The City of New York

The City of New York's Comments on the Proposed Plan for the Gowanus Canal Superfund Site

April 26, 2013

Figure 1-1

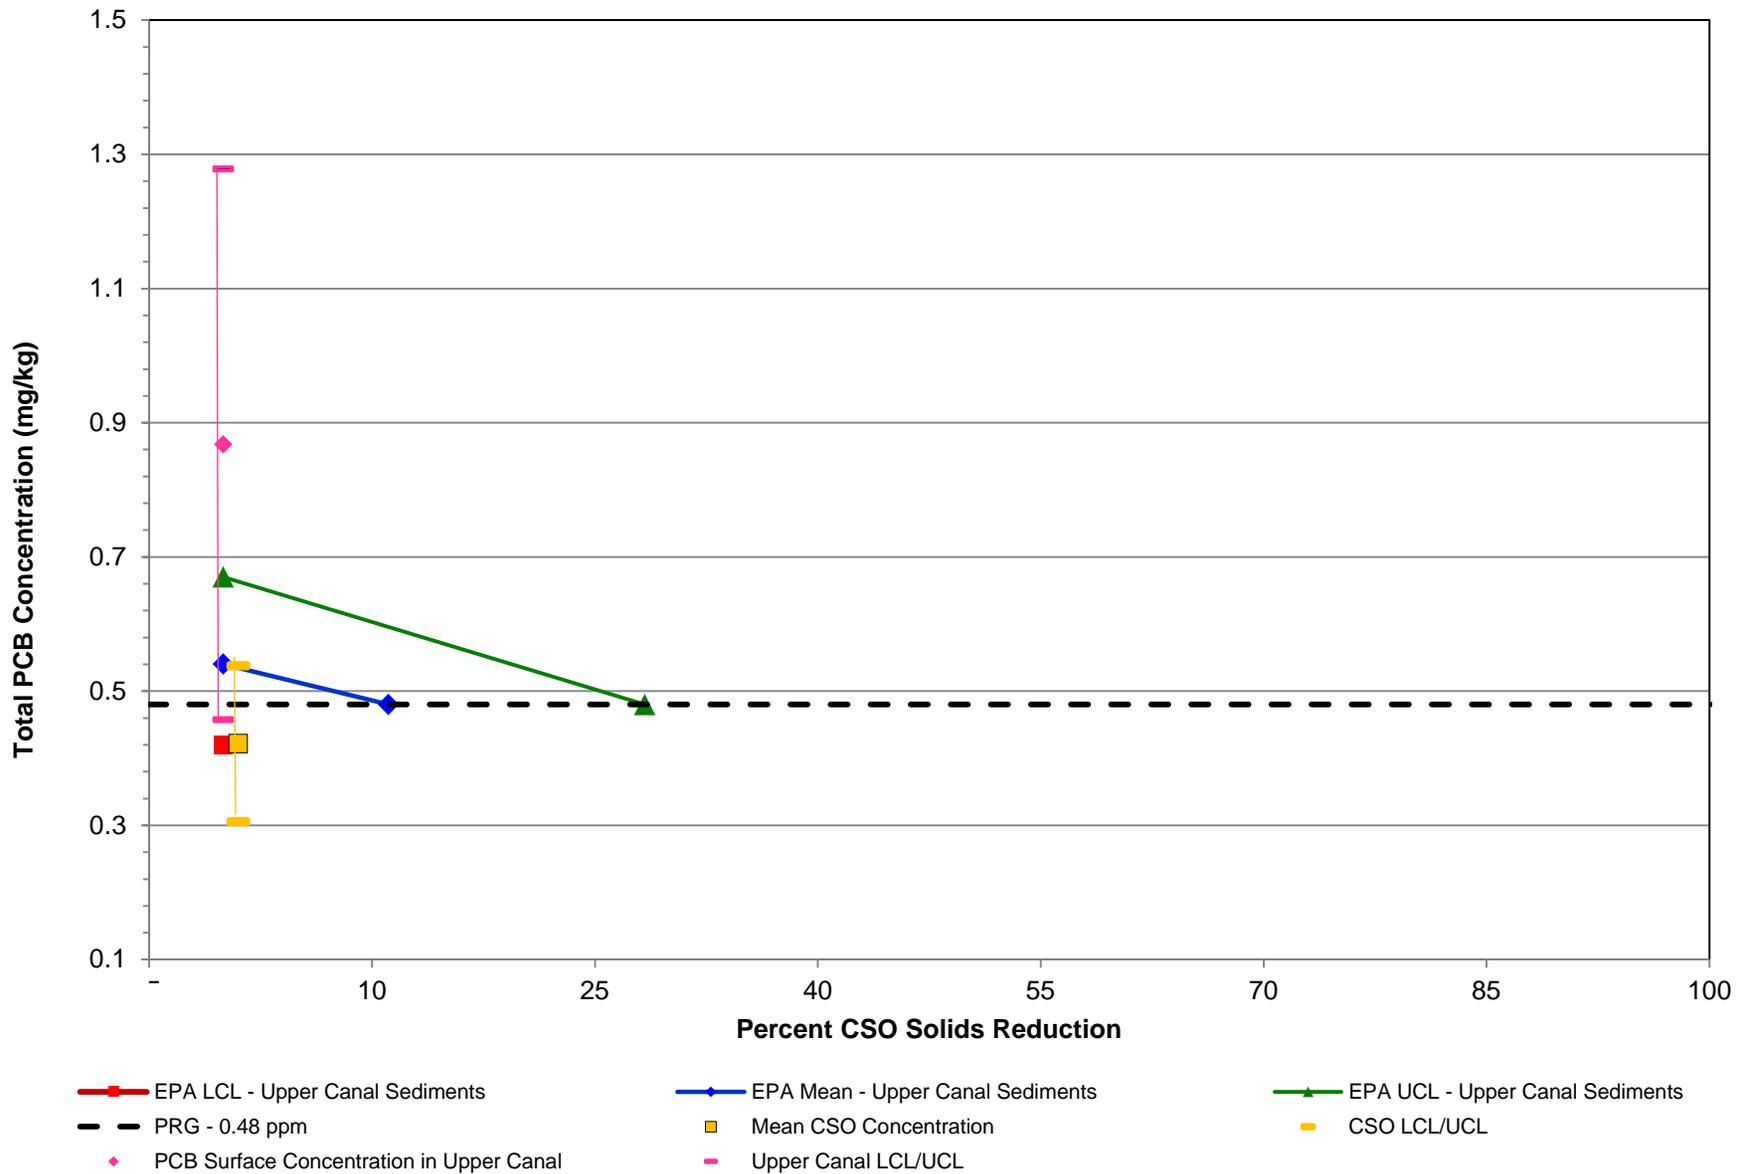
Based on this information, the City reconstructed the figure from the FS Addendum (see FS Addendum 7, Attachment) that EPA used to estimate the required CSO percentage reduction at RH-034 based on TPAHs. This is shown as Figure 1-1. The figure shows EPA's original calculation based on its estimate of TPAH concentrations in the surface sediments of the Upper Canal. Also shown on the diagram are two important additions. First, the TPAH concentration for CSO solids is shown, on a 6 percent TOC basis, *i.e.*, 5 mg/kg TPAH / 6 percent TOC. As noted above, this value is well below the PRG, indicating that CSO solids already satisfy the PRG value. Also shown on the diagram is the City's estimate of surface sediment concentrations in the Upper Canal. This value is more than five times greater than the estimate presented in the Proposed Plan. For the City's estimate, all data available for the Upper Canal were used, including the RI data obtained by EPA, data obtained by EPA's ERT and data obtained by the City during its own investigation of the Canal. The original EPA value was based only on the EPA's RI data, which appears biased substantially lower than the other two data sets.

This revised version of the EPA Percent Reduction Diagram yields two important conclusions. First, that CSOs are already in compliance with the proposed PAH PRG and no further CSO reduction is justified for TPAH control; and second, that surface concentrations and the source(s) of PAH contamination to the Upper Canal are indicative of a much more substantial load of PAHs to the Canal than that delivered by the CSOs, and will require a substantially greater reduction of PAH contamination (92 percent) to meet the EPA PRG than originally estimated in the Proposed Plan. The results for PCBs yield a similar conclusion and are discussed below.

Figure 1-2

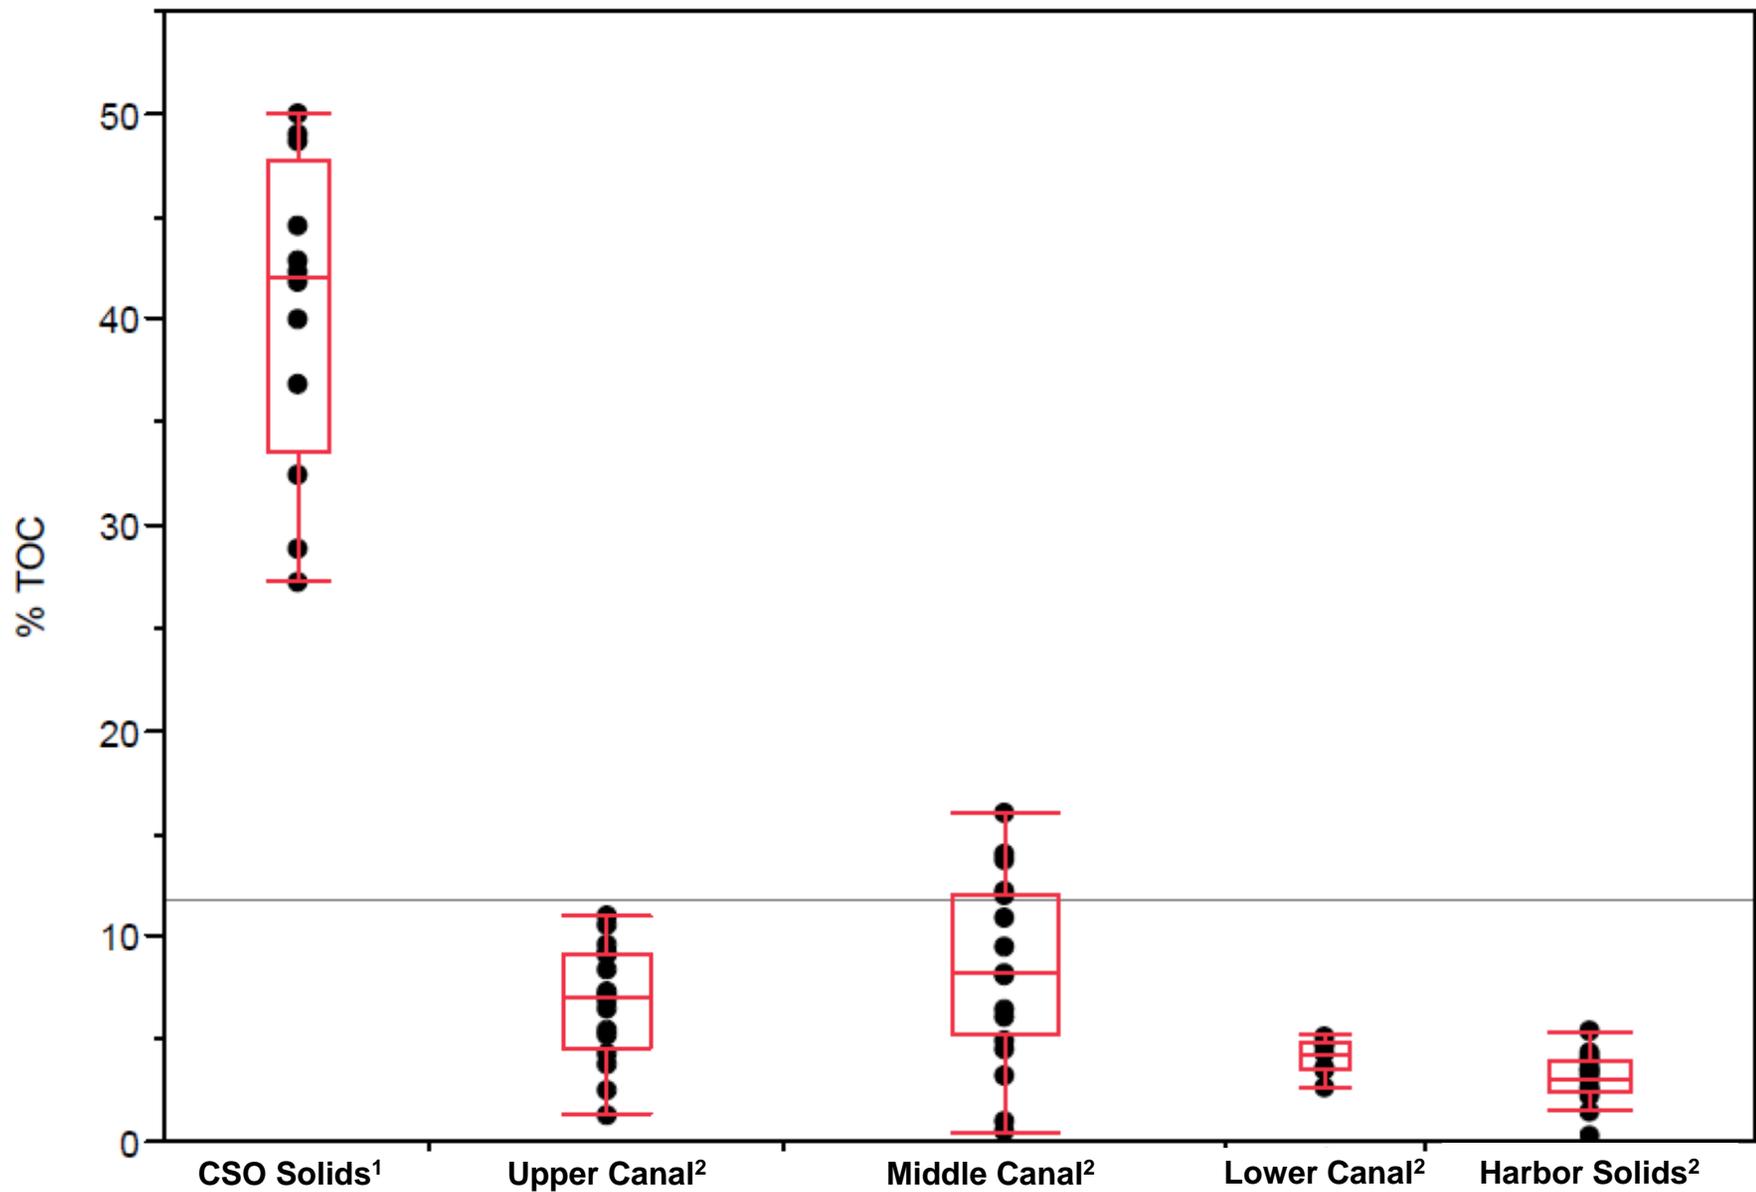
For TPCBs, the City repeated the reconstruction of the figure from the FS Addendum that EPA used to estimate the required CSO discharge percentage reduction at RH-034 (see FS Addendum 7, Attachment). This is shown as Figure 1-2. The figure shows EPA's original calculation based on its estimate of TPCB concentrations in the surface sediments of the Upper Canal. The City's figure has two important additions. First, the TPCB concentration for CSO solids is shown at 0.42 mg/kg. As noted above, this value is just below the PRG, indicating that again the CSO solids already satisfy the PRG value. The diagram also shows the City's estimate of surface sediment TPCB concentrations in the Upper Canal. In this instance, the City's value is twice EPA's value, at 0.96 mg/kg. This value was derived in a similar manner as for the TPAH samples, but limited to those samples with reported PCB congener results. Again, the original EPA value was based only on data collected in EPA's RI investigation; these data appear biased substantially lower than concentrations found in the other data sets.

This revised version of the EPA Percent Reduction Diagram yields the same two important conclusions as the TPAH results. First, that CSOs are already in compliance with the proposed PCB PRG and no further CSO reduction is justified for TPCBs control; and second, that surface concentrations and the source(s) of PCB contamination to the Upper Canal are substantially greater and will require a substantially greater reduction to meet the EPA PRG than originally estimated in the Proposed Plan.

Figure 2-1

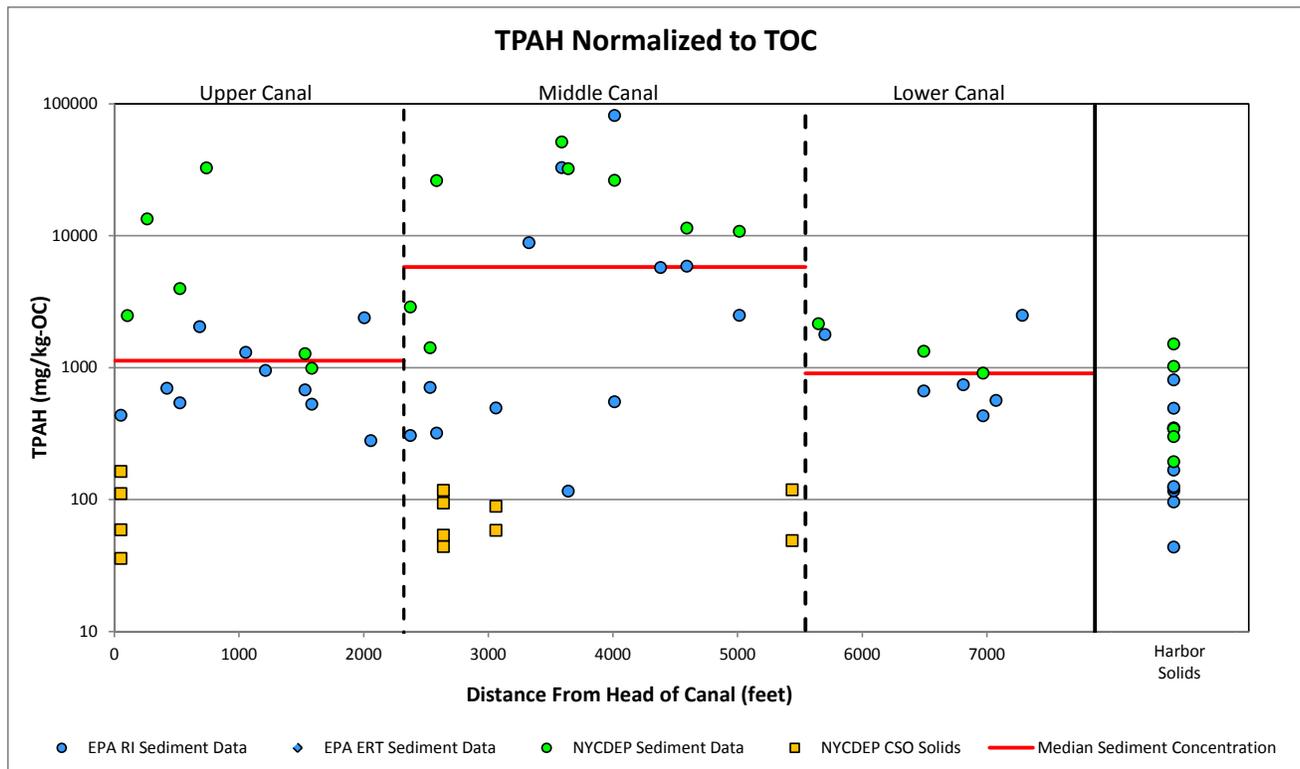
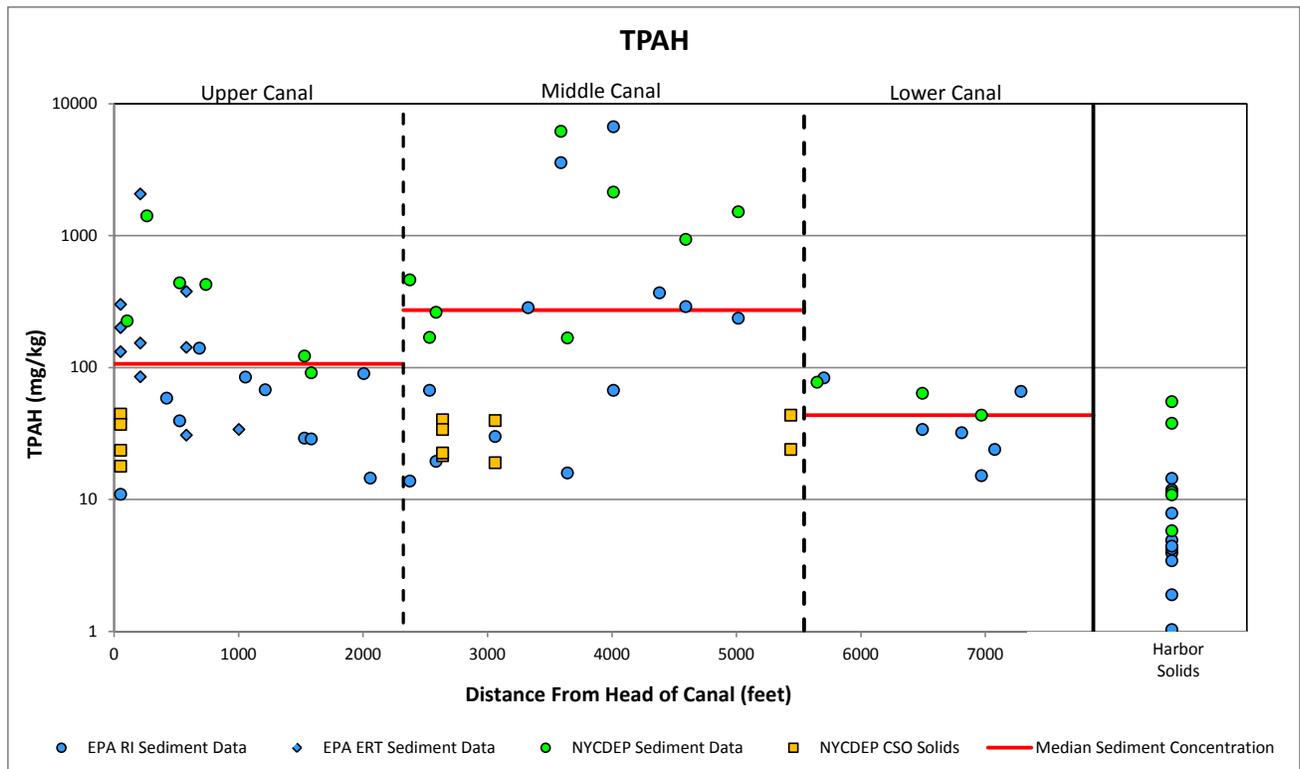
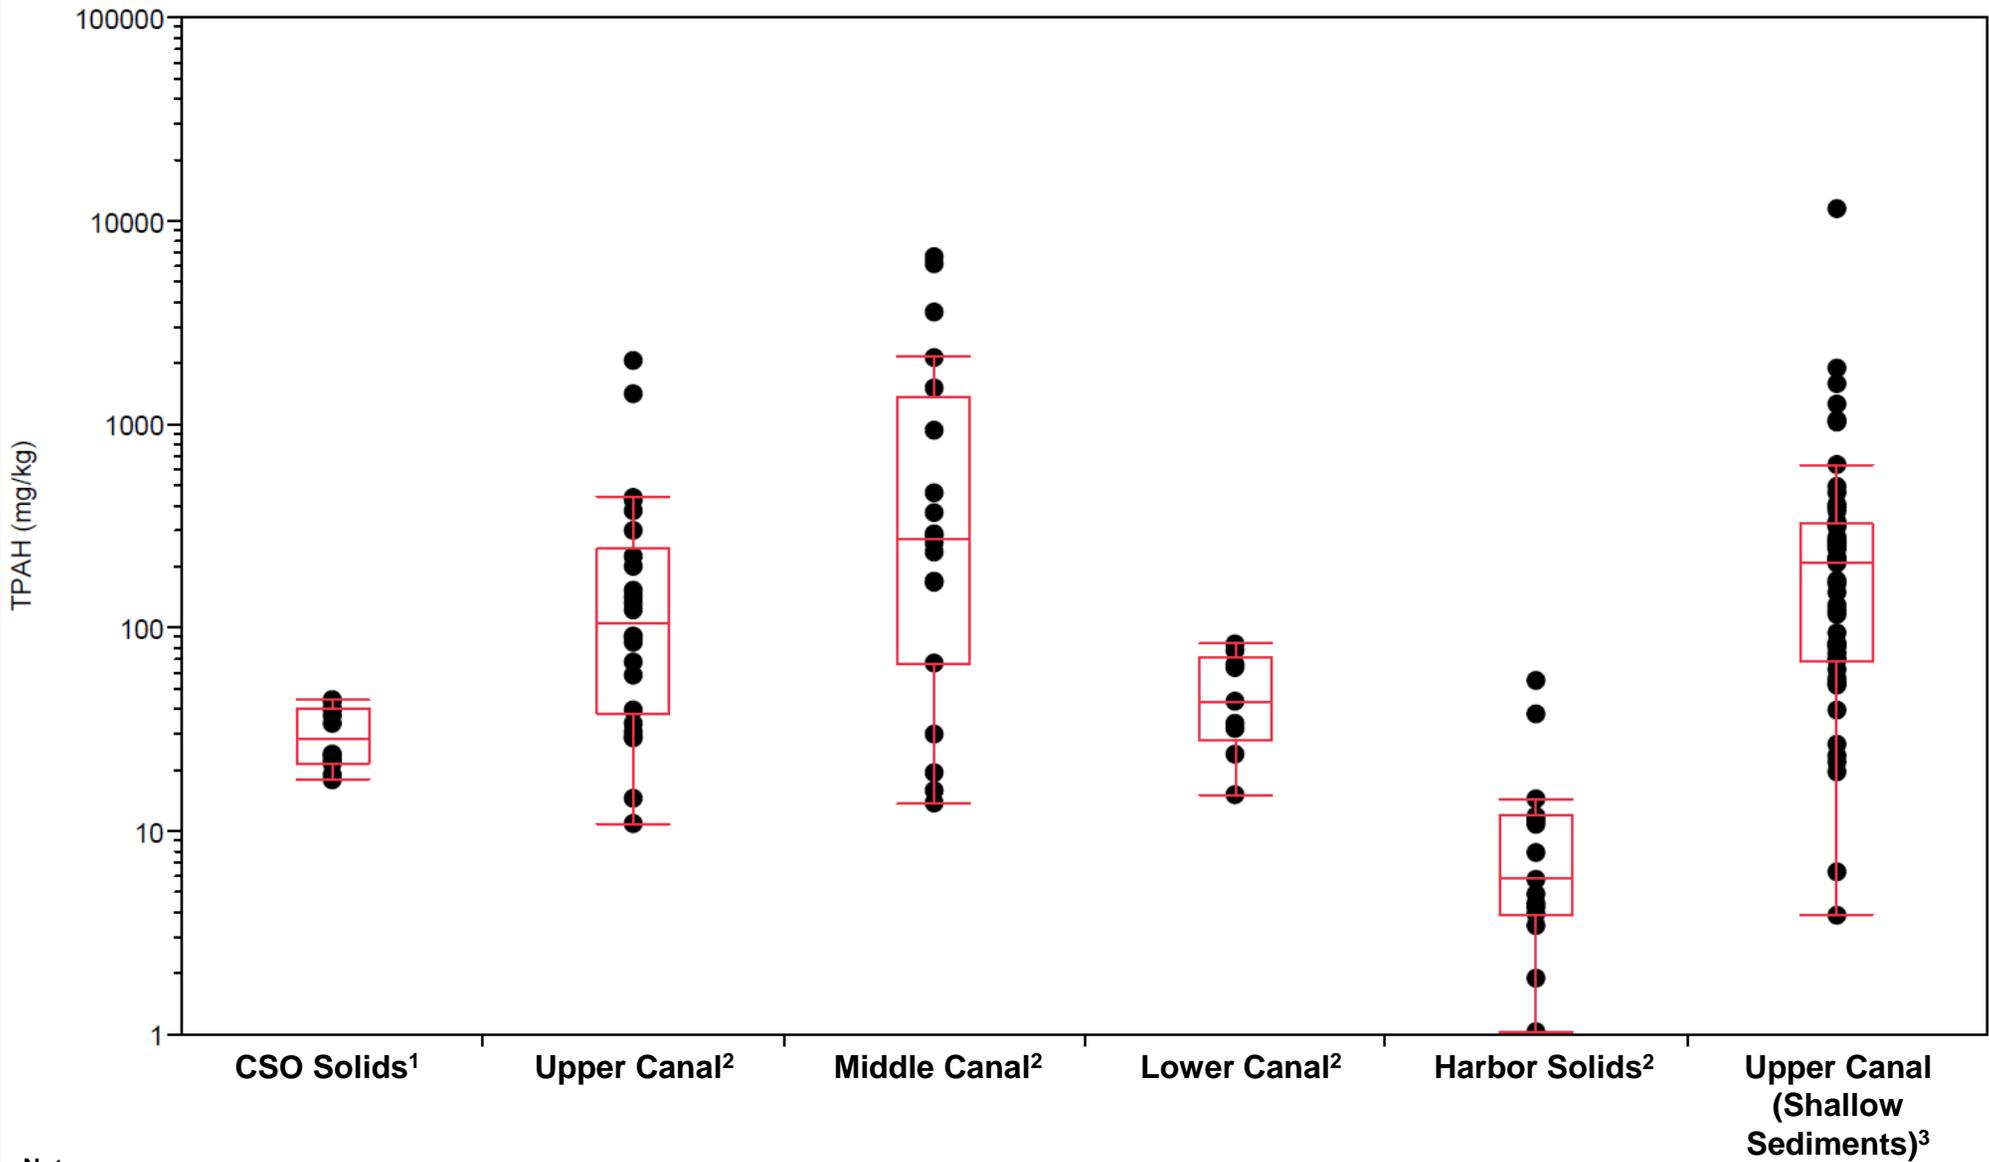
- The average concentration of organic carbon on CSO solids is 40 percent as compared to 3 percent on harbor solids (reference area, Figure 2-1) and 6 percent on sediments of the Upper Canal (Upper Reach, Figure 2-1). Thus, Upper Canal surface sediments are significantly closer in TOC content to harbor solids delivered by the Flushing Tunnel or by tidal exchange than they are to CSO solids, indicating they are primarily comprised of harbor solids.
